ADDENDUM 3

6/4/2025
Capstone at Convington Place
24-064

The Banyan Foundation

1 OVERALL 2ND FLOOR MECHANICAL PLAN
1/16" = 1'-0"

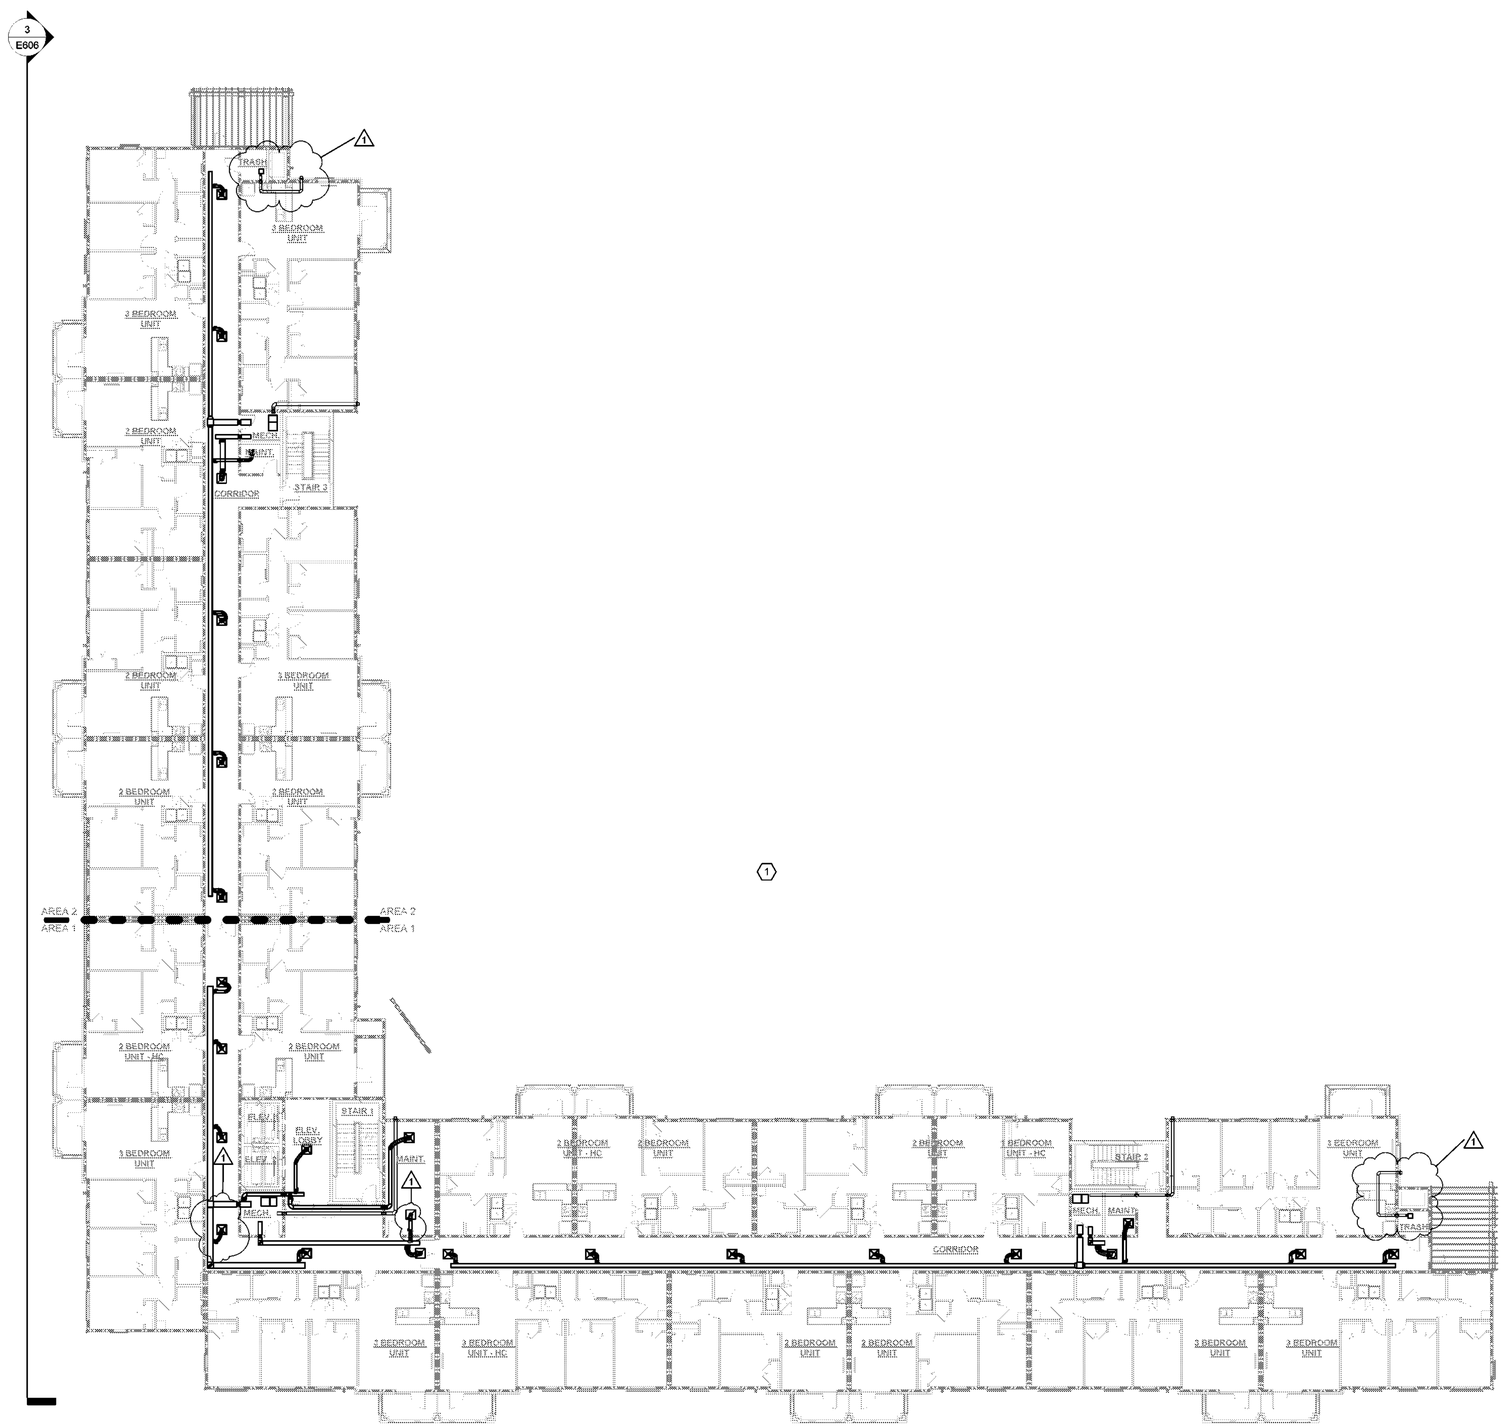
Add 1.56 **M203 – Overall 2nd Floor Mechanical Plan**
- Note changes to 1M203.

1 PARTIAL 2ND FLOOR MECHANICAL PLAN - AREA 1
3/32" = 1'-0"

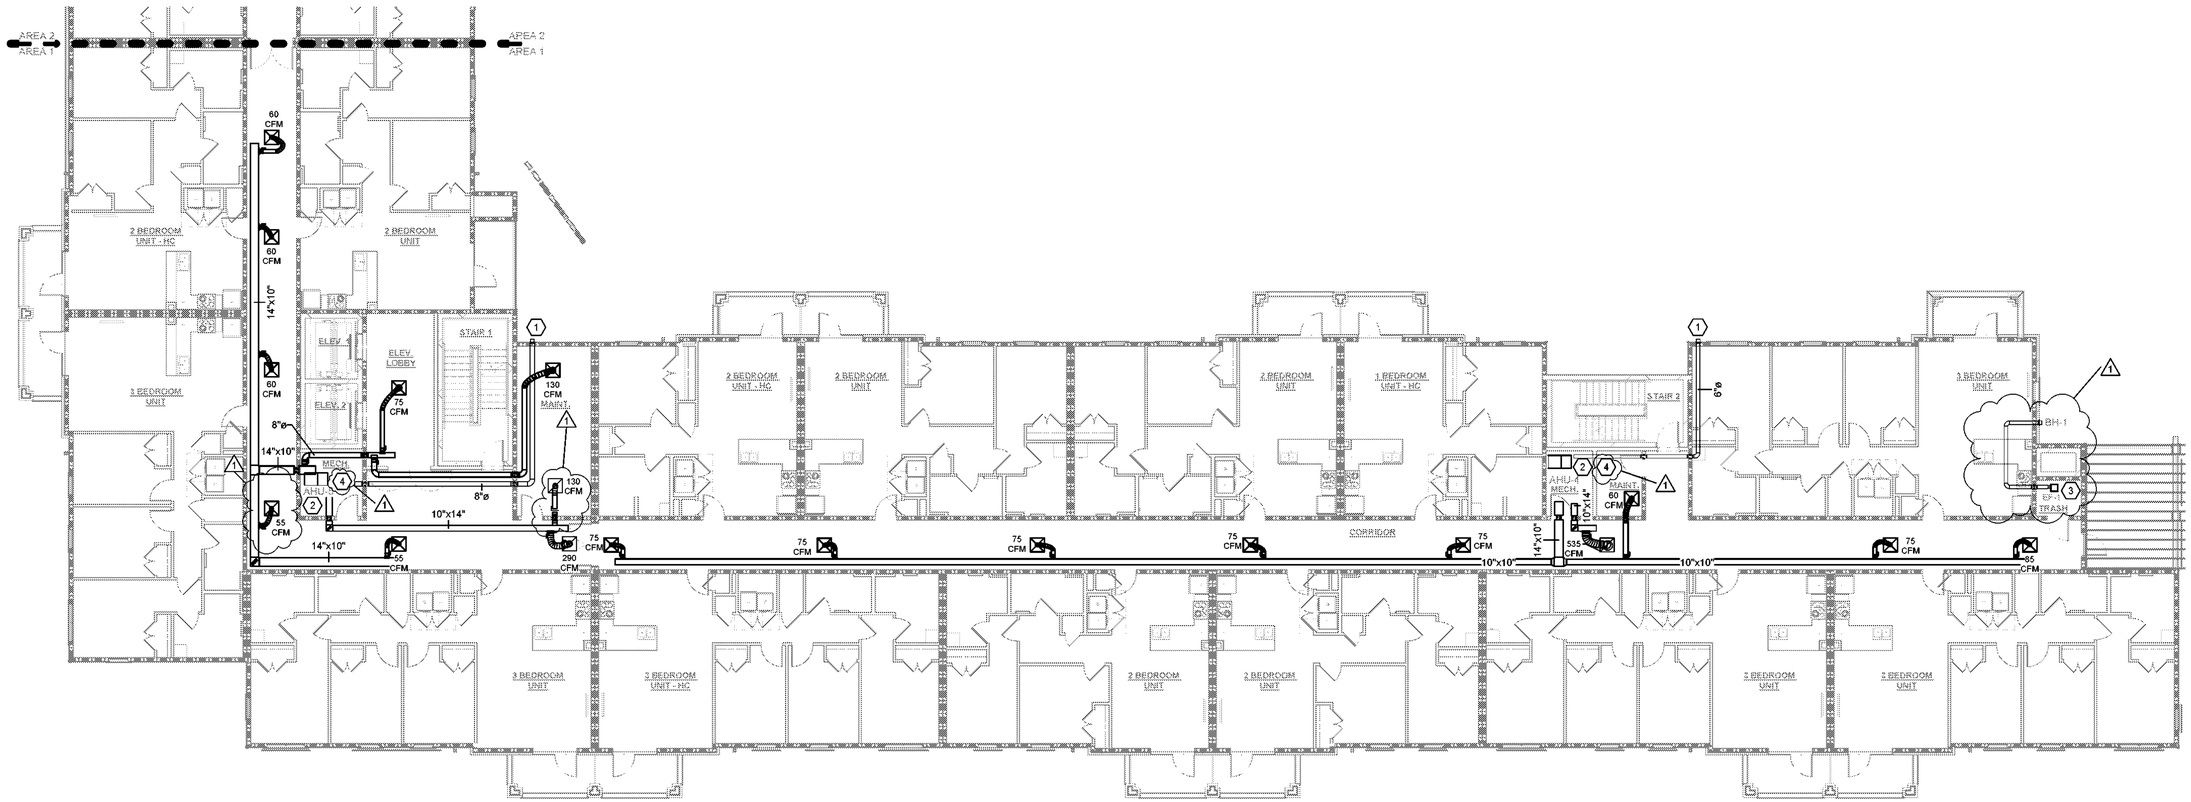
Add 1.57 **M204 – Partial, 2nd Floor Mechanical Plan – Area 1**
- Note changes to 1M204.
- Note changes to Specific Notes.

1 PARTIAL 2ND FLOOR MECHANICAL PLAN - AREA 2
3/32" = 1'-0"

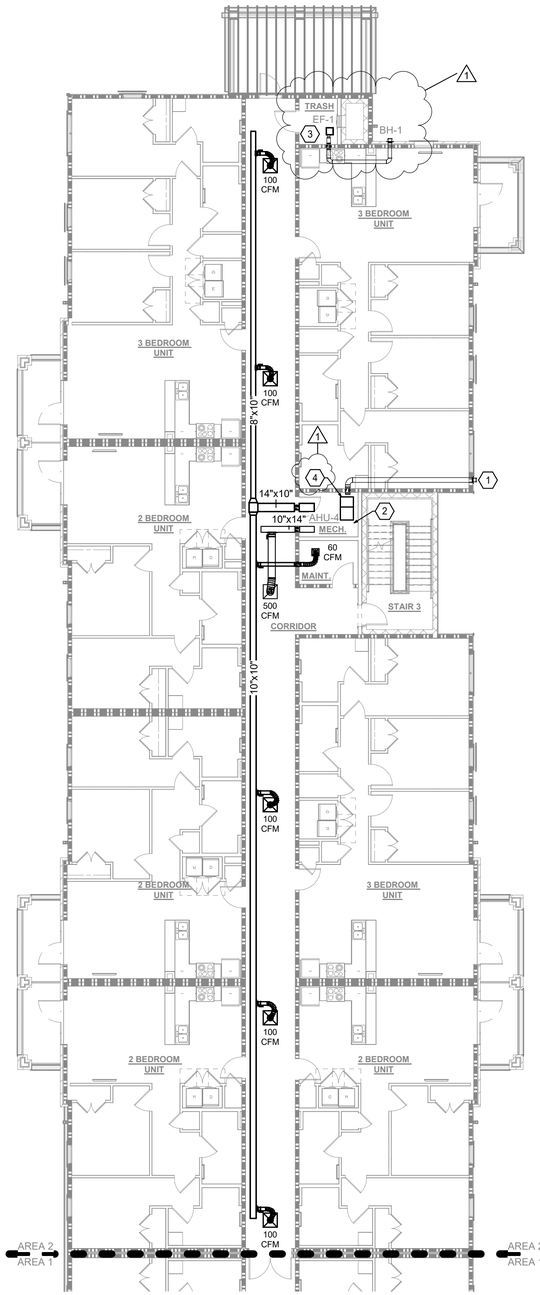
Add 1.58 **M205 – Partial, 2nd Floor Mechanical Plan – Area 2**
- Note changes to 1M205.
- Note changes to Specific Notes.

1 PARTIAL 3RD FLOOR MECHANICAL PLAN - AREA 1
3/32" = 1'-0"

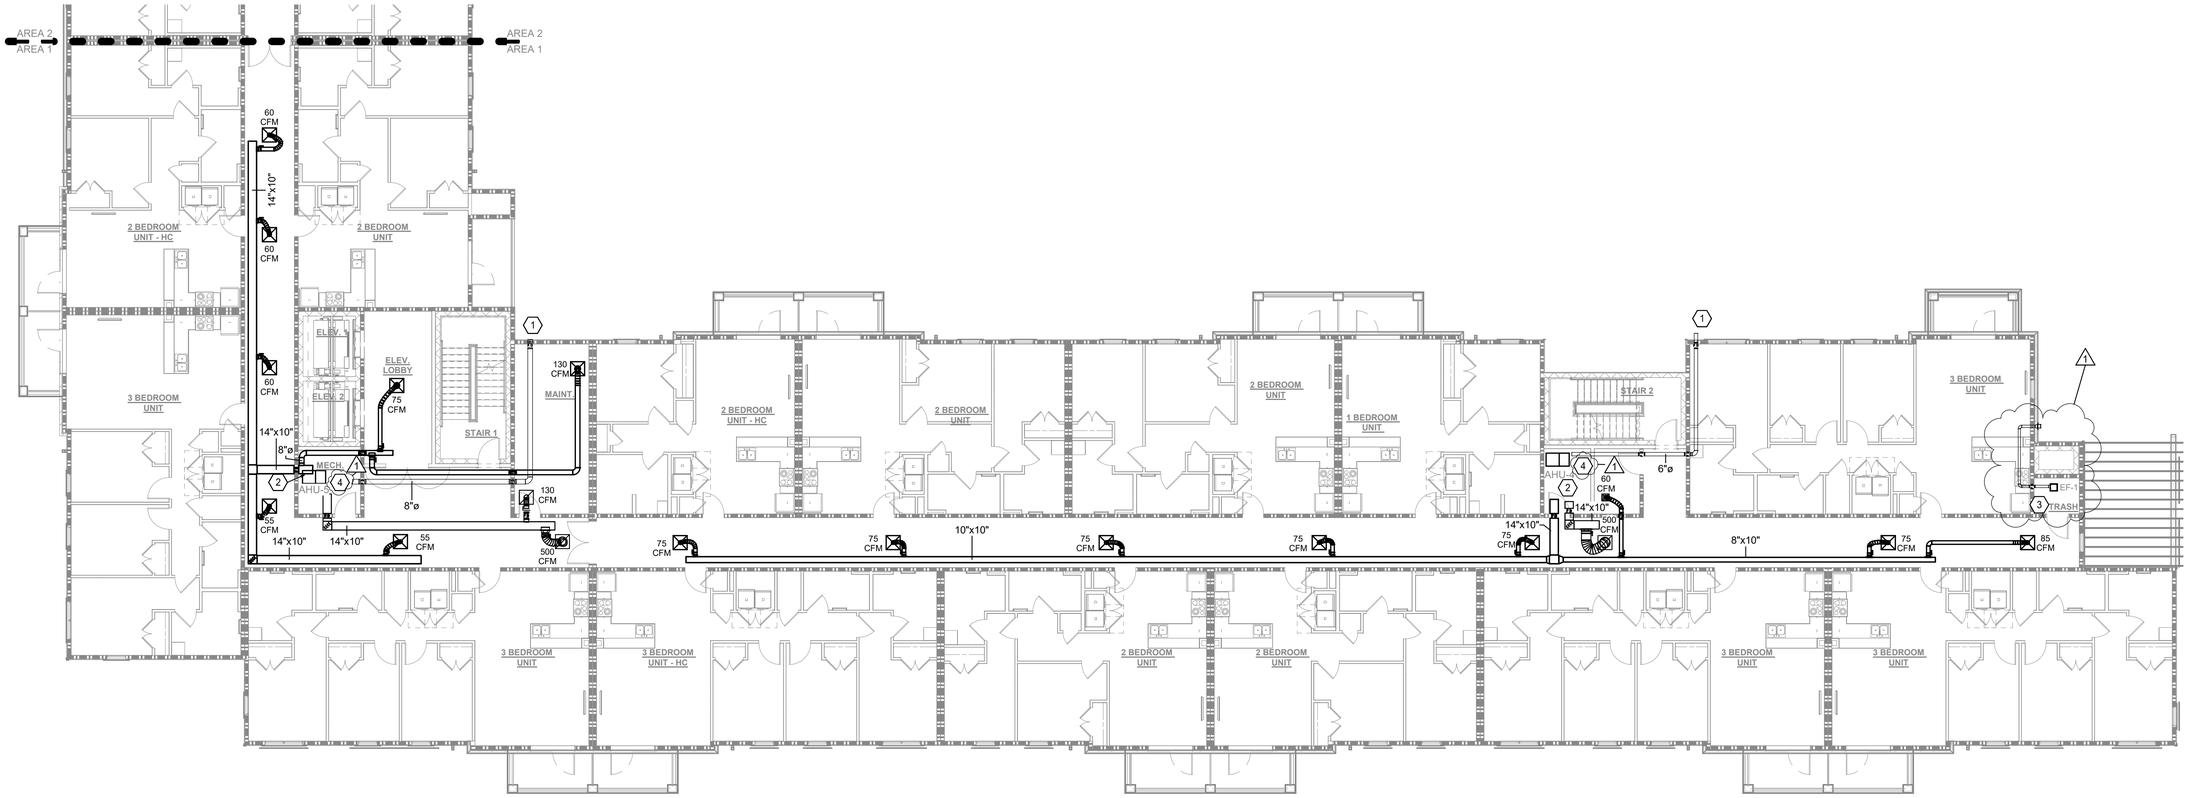
Add 1.60 **M207 – Partial, 3rd Floor Mechanical Plan – Area 1**
- Note changes to 1M207.
- Note changes to Specific Notes.

1 PARTIAL 3RD FLOOR MECHANICAL PLAN - AREA 2
3/32" = 1'-0"

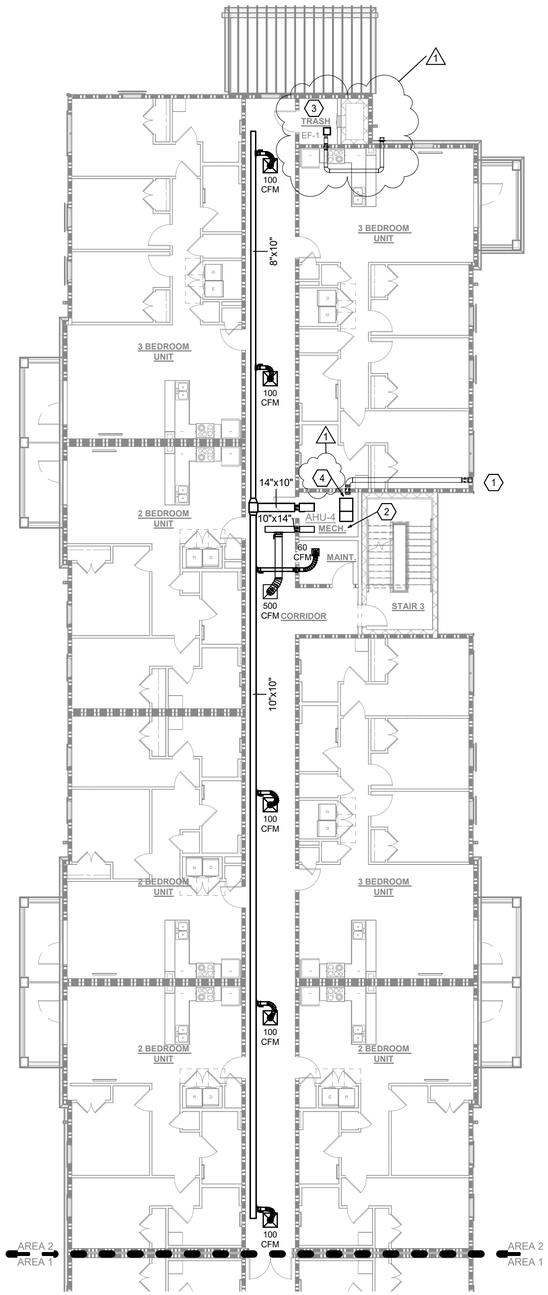
Add 1.61 **M208 – Partial, 3rd Floor Mechanical Plan – Area 2**
- Note changes to 1M208.
- Note changes to Specific Notes.

1 PARTIAL 4TH FLOOR MECHANICAL PLAN - AREA 1
3/32" = 1'-0"

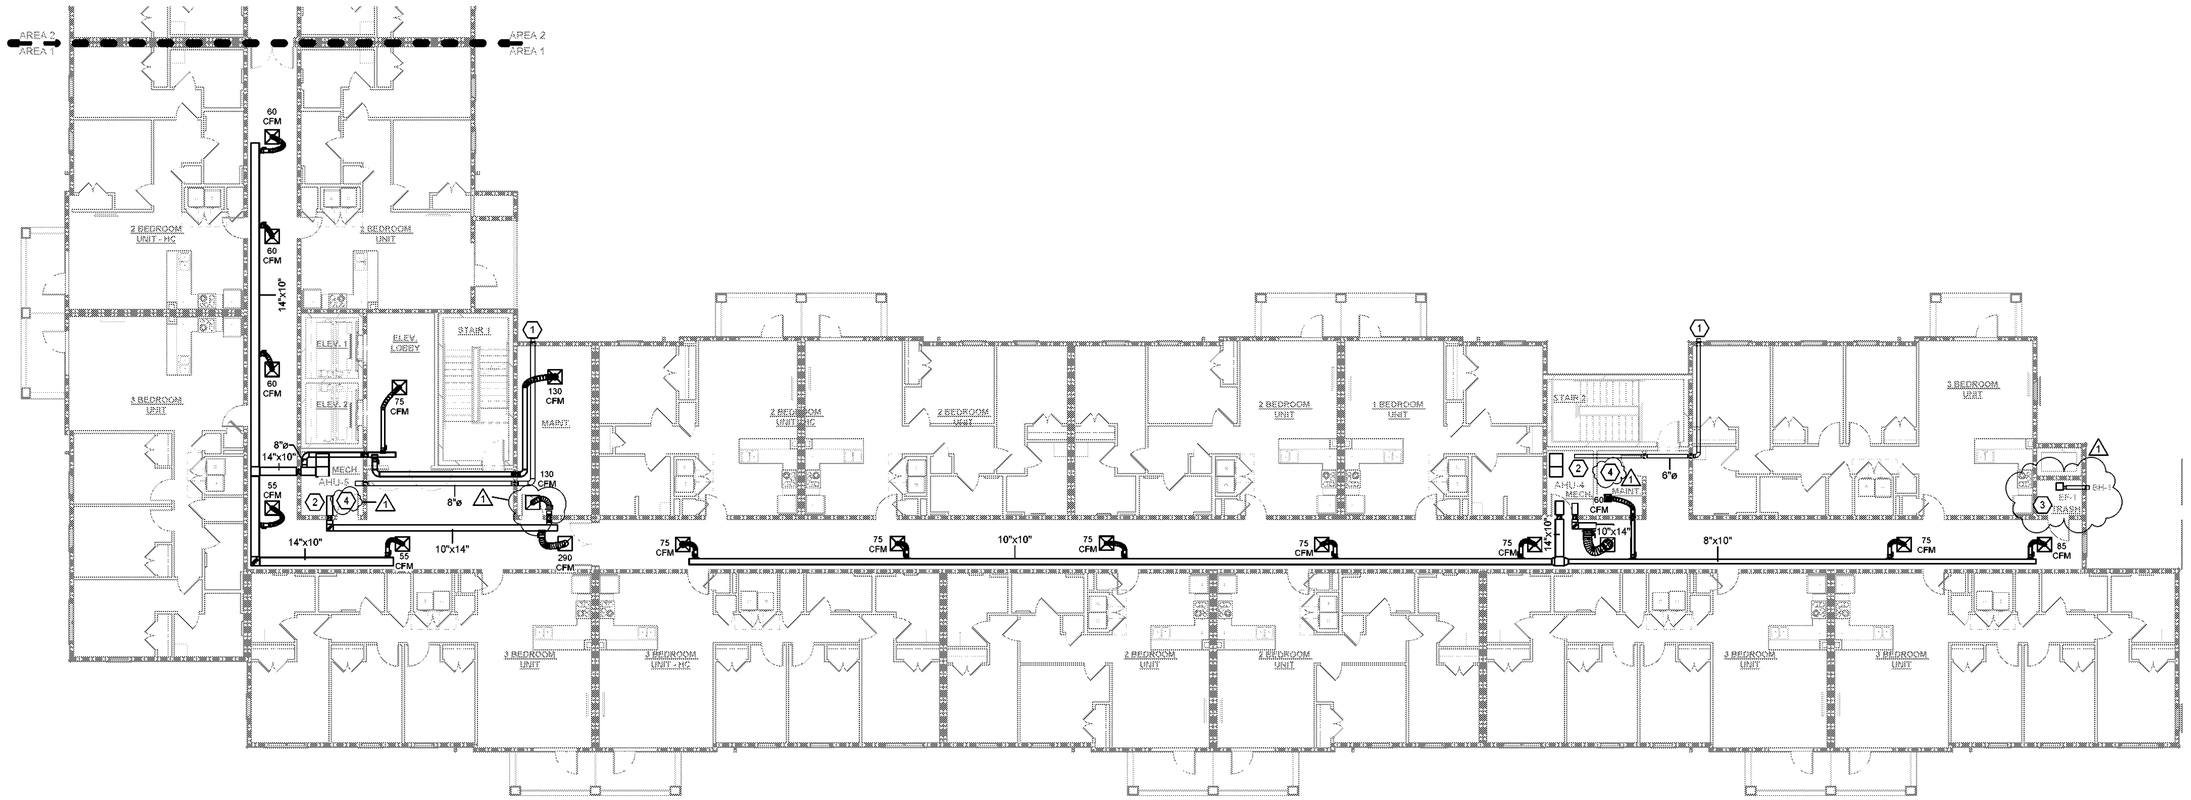
Add 1.63 **M210 – Partial, 4th Floor Mechanical Plan – Area 1**
- Note changes to 1M210.
- Note changes to Specific Notes.

1 PARTIAL ROOF MECHANICAL PLAN - AREA 1
3/32" = 1'-0"

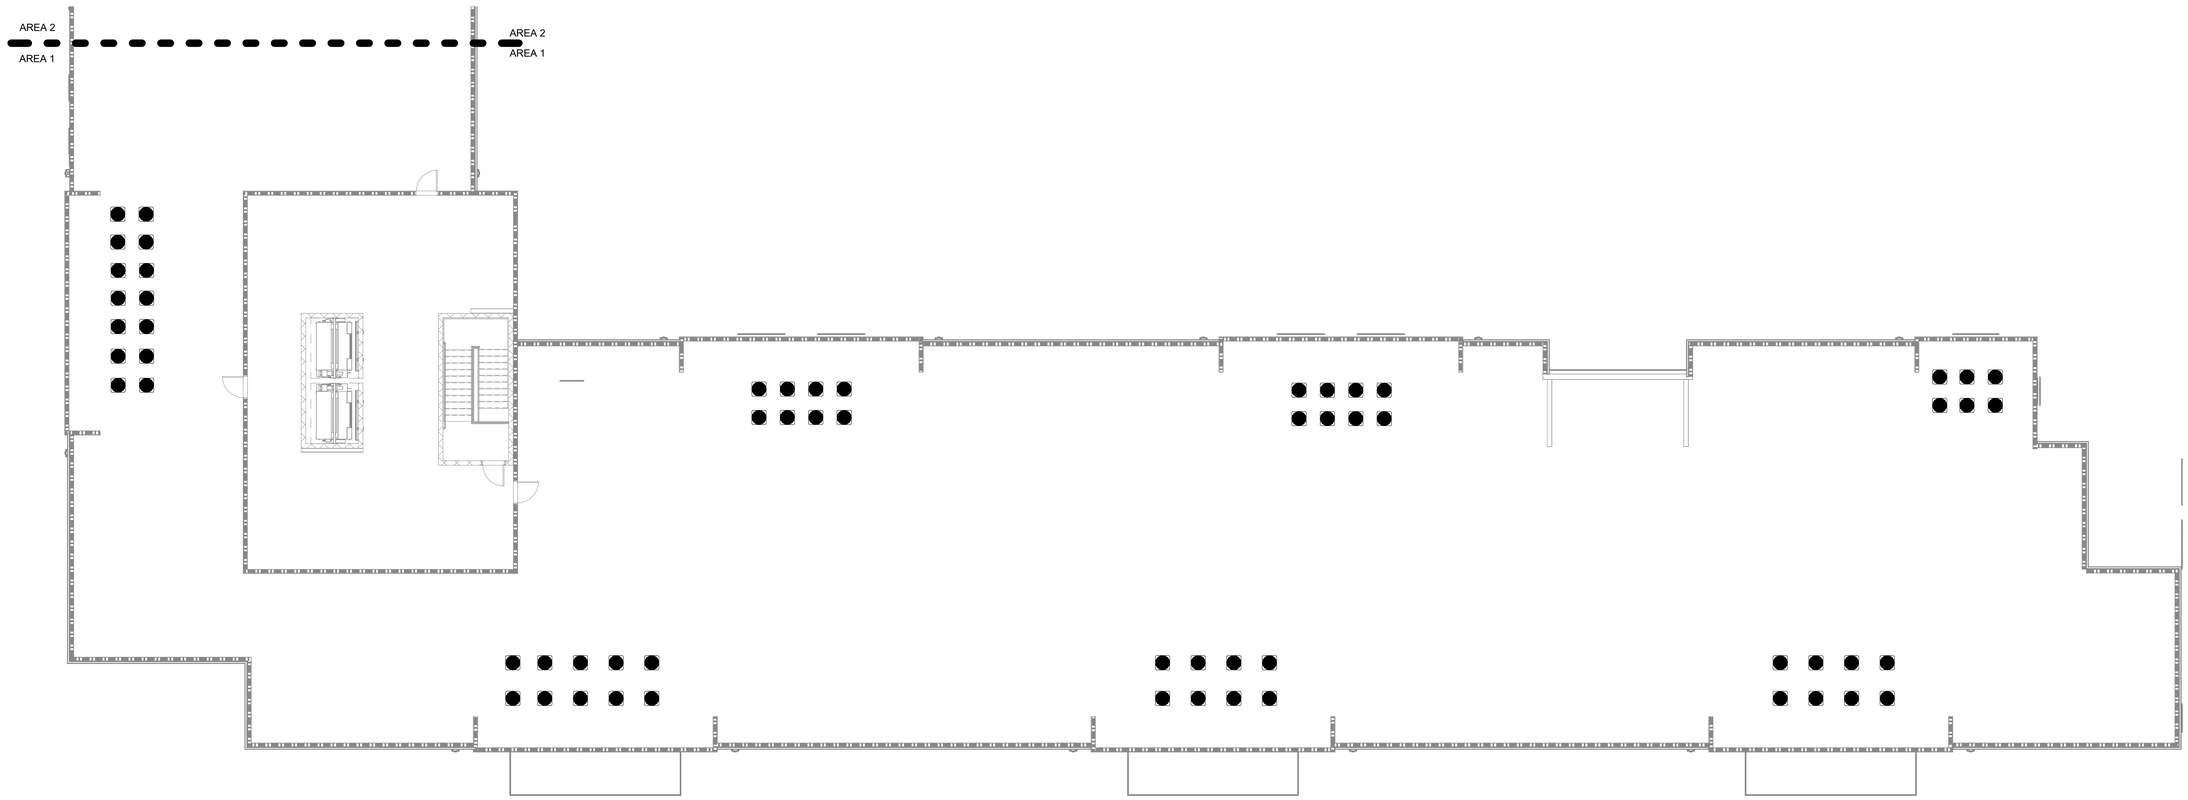
Add 1.66 **M213 – Partial Roof Mechanical Plan – Area 1**
- Note changes to entire sheet.

1 PARTIAL ROOF MECHANICAL PLAN - AREA 2
3/32" = 1'-0"

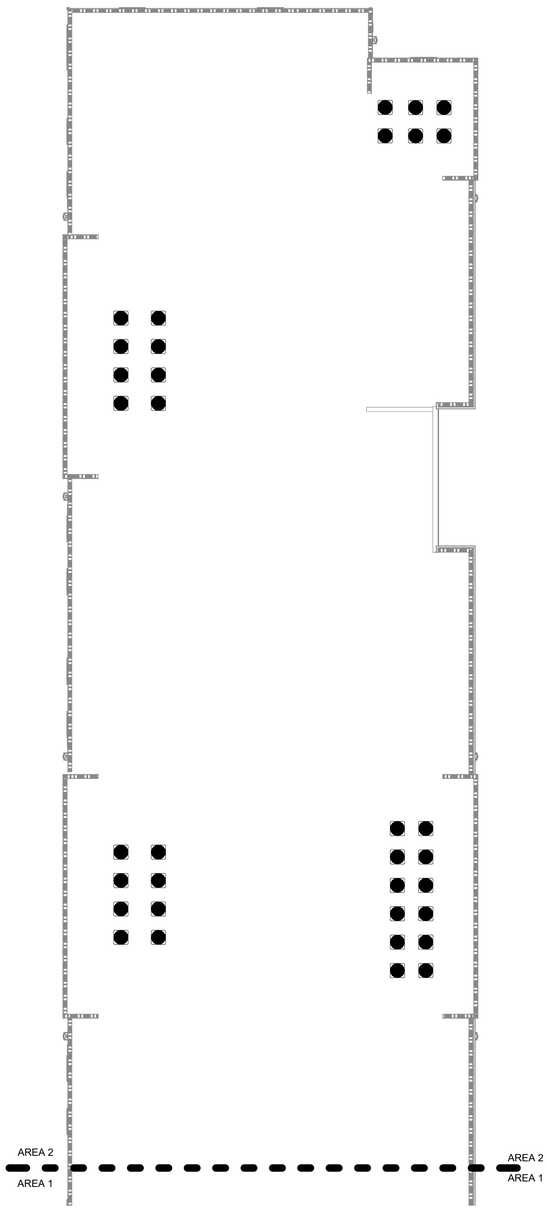
Add 1.67 **M214 – Partial Roof Mechanical Plan – Area 2**
- Note changes to entire sheet.
